CITY OF STOUGHTON
DEPARTMENT OF
PLANNING & DEVELOPMENT
207 S. Forrest Street, Stoughton, WI. 53589

Date: January 14, 2021

Subject: 2021 Street & Sidewalk Project Design Points

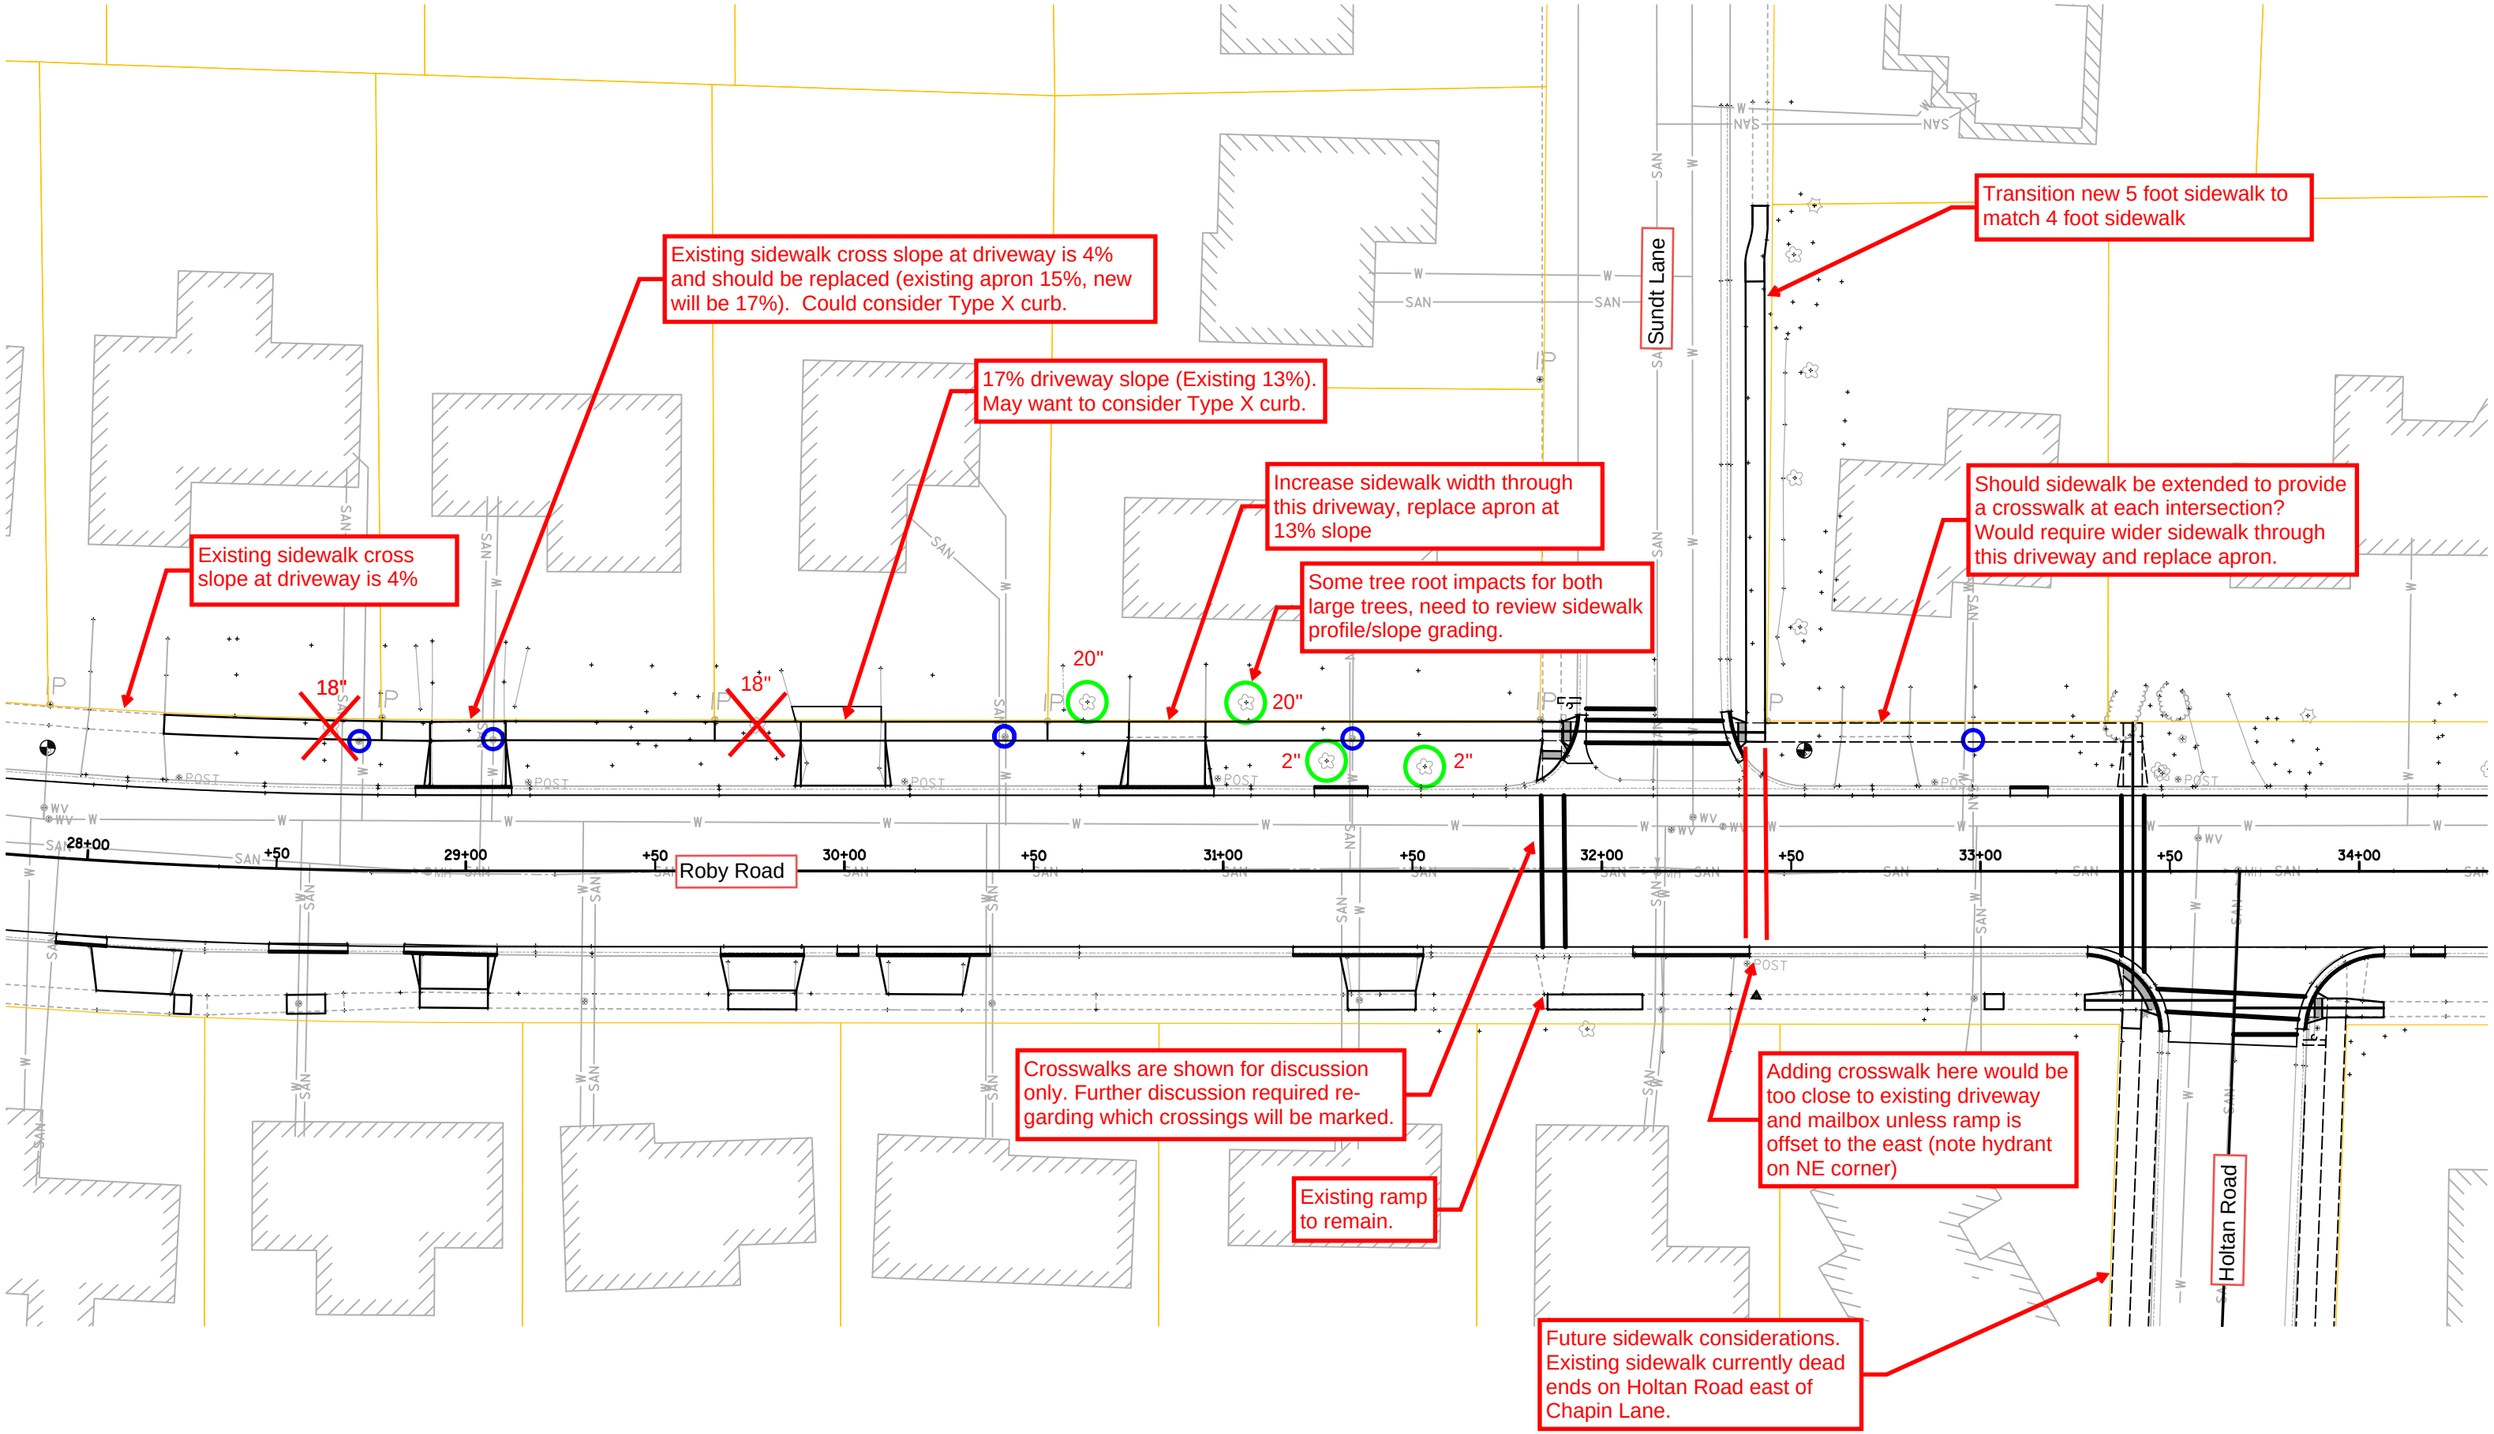
Existing sidewalk cross slope at driveway is 4% and should be replaced (existing apron 15%, new will be 17%). Could consider Type X curb.
17% driveway slope (Existing 13%). May want to consider Type X curb.
Increase sidewalk width through this driveway, replace apron at 13% slope
Some tree root impacts for both large trees, need to review sidewalk profile/slope grading.
Transition new 5 foot sidewalk to match 4 foot sidewalk
Should sidewalk be extended to provide a crosswalk at each intersection? Would require wider sidewalk through this driveway and replace apron.
Existing sidewalk cross slope at driveway is 4%
Sundt Lane
Roby Road
Holtan Road
18"
18"
20"
20"
2"
2"
28+00
29+00
30+00
31+00
32+00
33+00
34+00
Crosswalks are shown for discussion only. Further discussion required regarding which crossings will be marked.
Existing ramp to remain.
Adding crosswalk here would be too close to existing driveway and mailbox unless ramp is offset to the east (note hydrant on NE corner)

Future sidewalk considerations. Existing sidewalk currently dead ends on Holtan Road east of Chapin Lane.
